TECHNICAL NOTE

JBA Project Code Q25-2520
Client South Cerney Parish Council
Date 10/11/2025
Authors: Emily Cumming
Benjamin Briere De L'Isle
Subject Review of supporting evidence documents in
planning application PL/2023/03359

Figure 1: Drainage Network on and around Site

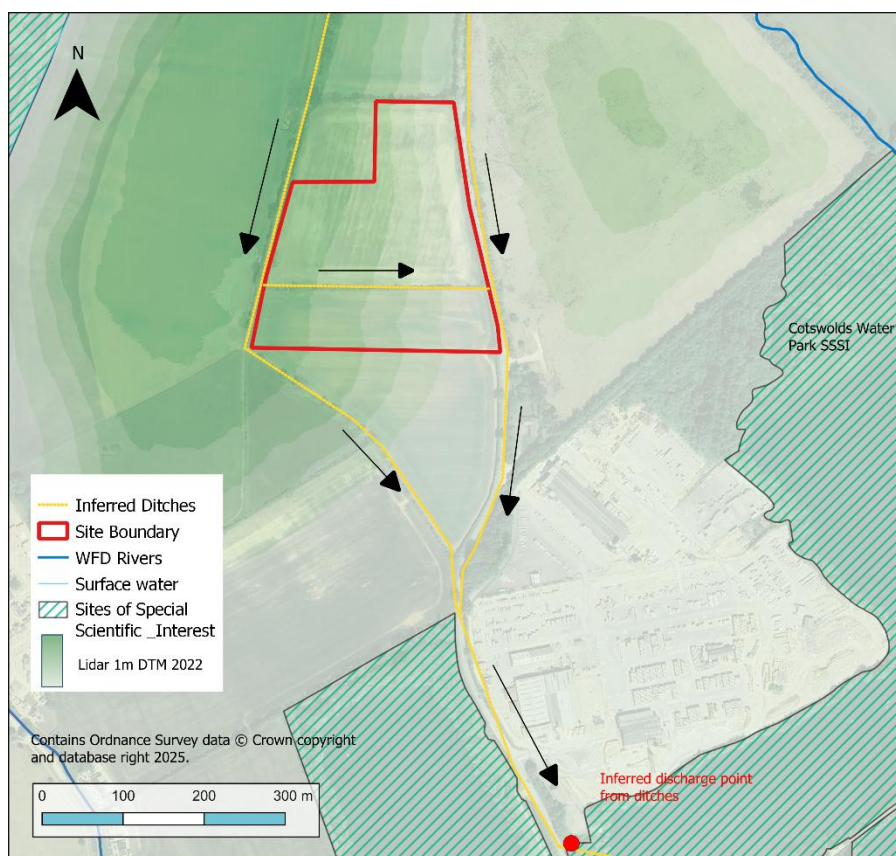
7. The “Ashton Road drainage ditch”, noted as the receptor for the proposed lagoon outfall in the ES (6.153) has not been traced or sufficient site catchment analysis made; the ES relies on the existence of the “highways ditch” as a safe drainage receptor, but this flows downhill directly towards the Cotswold Water Park SSSI 500 m away, as seen in Figure 1.
